SUBDIVISION REVIEW SHEET

CASE NO.: C8-2022-0287.1A

SUBDIVISION NAME: Three Hills Apartments

**CITY OF AUSTIN –DEVELOPMENT SERVICES DEPARTMENT
SUBDIVISION APPLICATION – MASTER COMMENT REPORT**

VICINITY MAP — N.T.S.

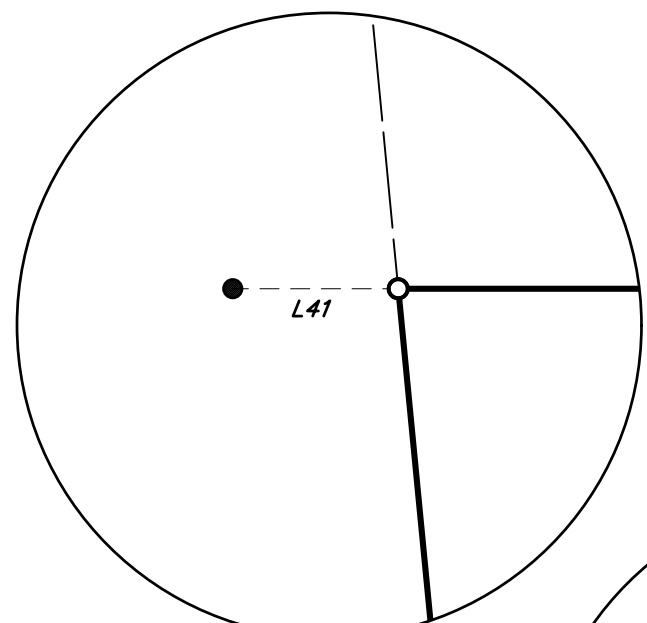
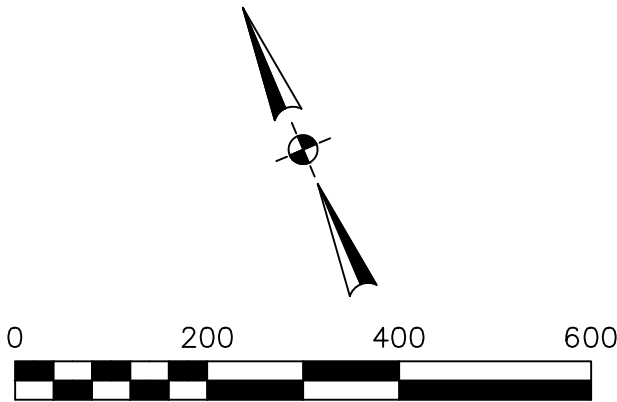
AD2: Please update the following labels in the exhibit and vicinity map:

AD3: Please remove all forms of punctuation after abbreviating street types or directionals including the vicinity map

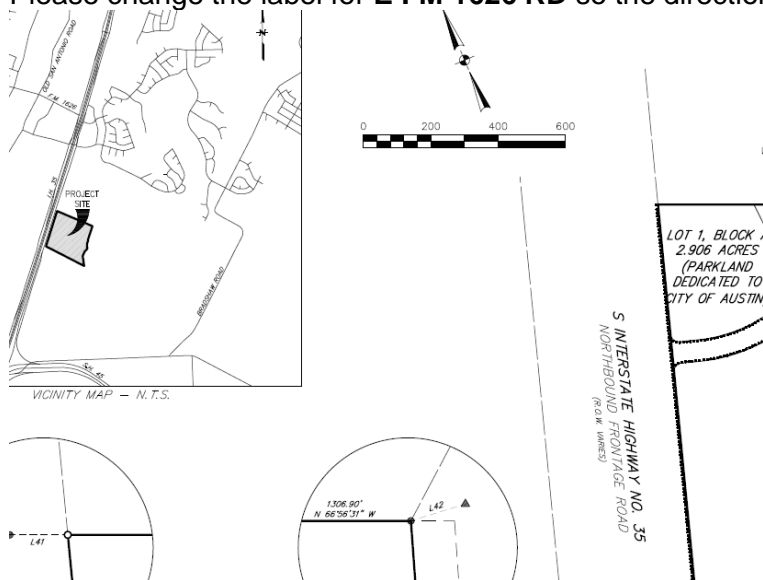
1. Please change the label for **S IH 35 SVRD NB** so the directional S must be included
2. Please change the label for **S SH 45 E** so the directional S must be included
3. Please change the label for **E FM 1626 RD** so the directional E must be included
